Historic Preservation Design Review

HP-11-21, Opera House Parking Lot (City)

Request: Design review approval for proposed redesign of the parking lot and landscaping for the existing parking lot behind the Opera House.

Pictured Above: Proposed Project Area View from E. Liberty St. Looking North

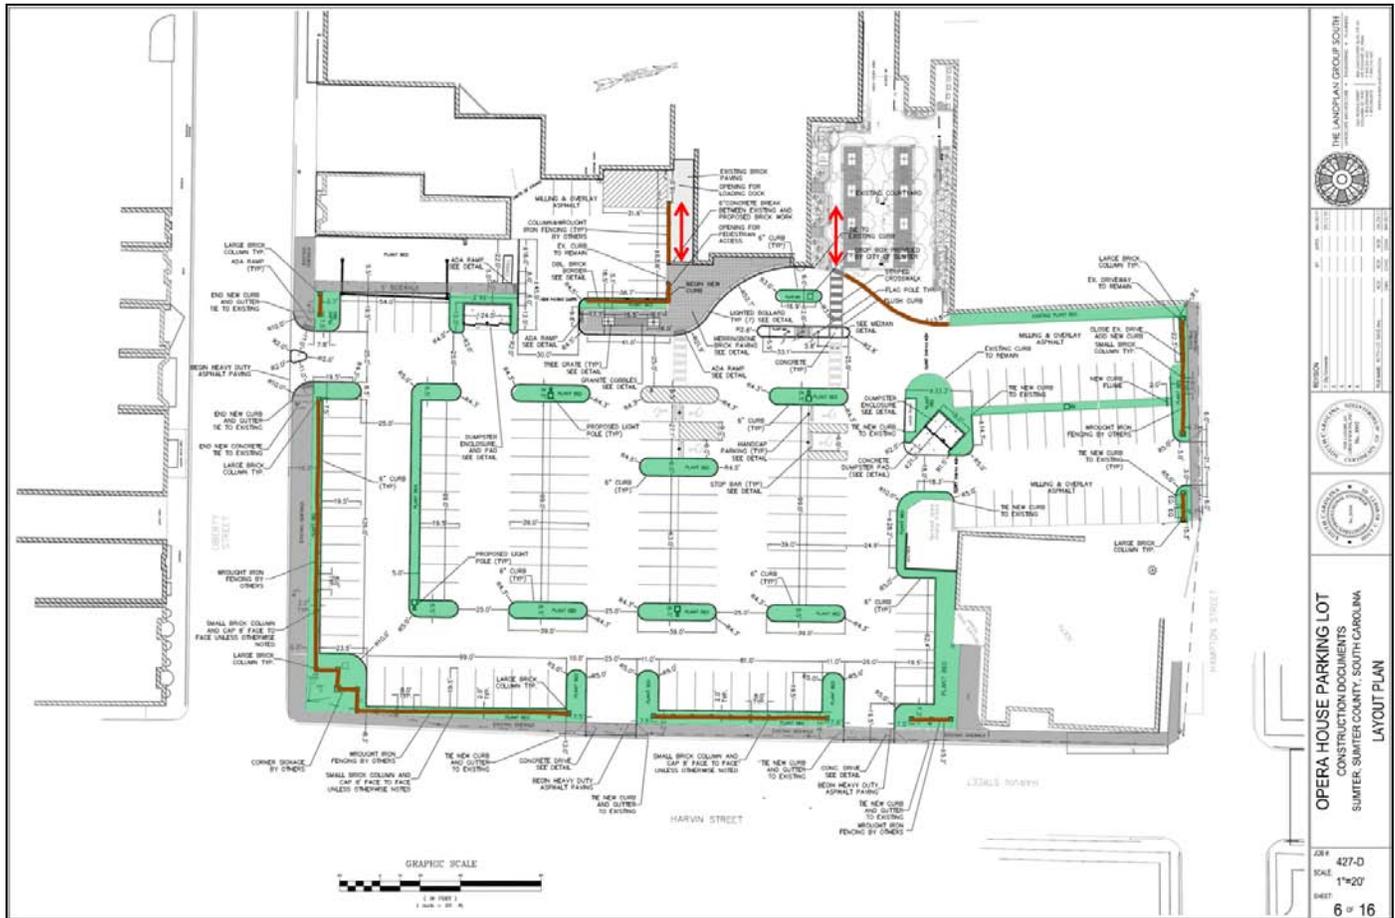
The applicant is requesting a Certificate of Appropriateness for redesign and rebuild of a 162 space parking lot and associated landscaping to be constructed at the northeast corner of the intersection of N. Harvin & E. Liberty Sts. The current parking layout is inefficient with poor access.

The project area is comprised of 15 separate parcels and will affect the areas outlined in the graphic to the right. The development site is located partially inside the designated National Register District and entirely within the boundary of the Downtown Review District. Any new parking lot developments must be reviewed by the Board for compliance with landscape and site design criteria.

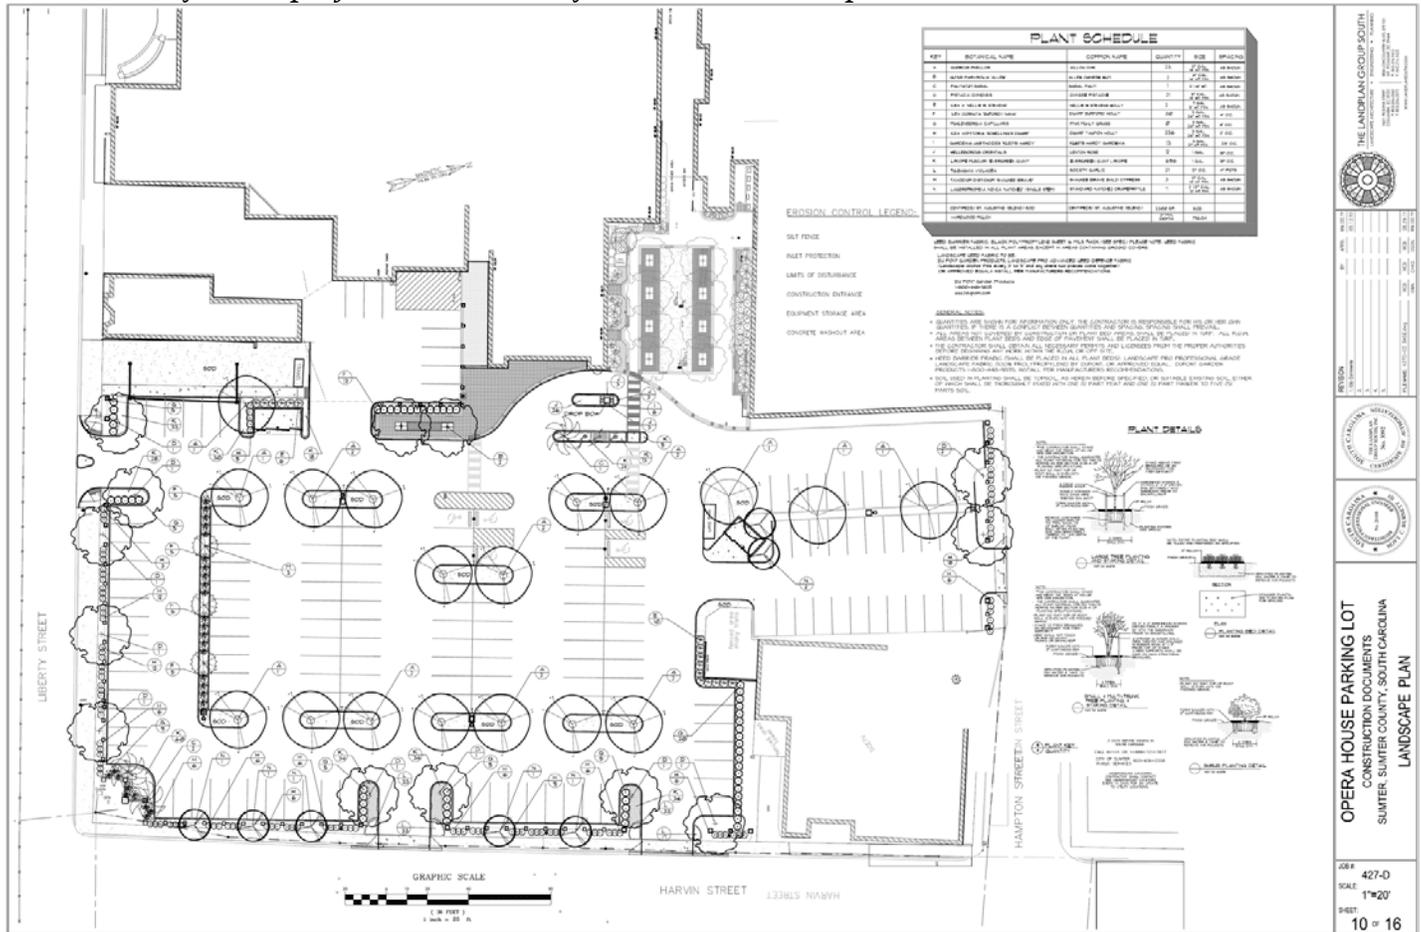
The site plan below shows the proposed layout for the parking lot. There are bufferyards proposed on all three street frontages a minimum of 5 ft. in width and integrated landscape islands are planned inside the parking lot—these areas are indicated in green. Additionally, as part of the landscape bufferyard, brick column and wrought iron fencing similar to that at the parking lot at N. Sumter & W. Hampton Ave. is to be provided around the parking lot in the locations indicated by the brown lines. Sidewalks exist on all three street frontages, shown in gray; and there is pedestrian access from the parking lot to N. Main St. in two locations indicated by the red arrows.

As shown in the landscape plan above and the site plan on page 2 of this report, a combination of canopy trees, understory trees, shrubbery and brick and wrought iron fencing will be used to screen the proposed parking lot on all three street frontages. In addition, the submitted landscape plan exceeds Zoning Ordinance landscaping requirements for parking lots.

The proposed parking lot design maintains the building rhythm through landscape elements and street front brick and wrought iron fencing.

The tree and shrubbery selection for this plan are based on the location of the parking lot. This parking lot is visible from three street frontages and to the rear of the buildings fronting N. Main St. The selected plant species have been chosen to complement the existing and proposed streetscape improvements within the Downtown. All planting beds and tree separation meet the above referenced criteria.

Staff has reviewed this request in accordance with the design guidelines. Staff recommends approval of this request.
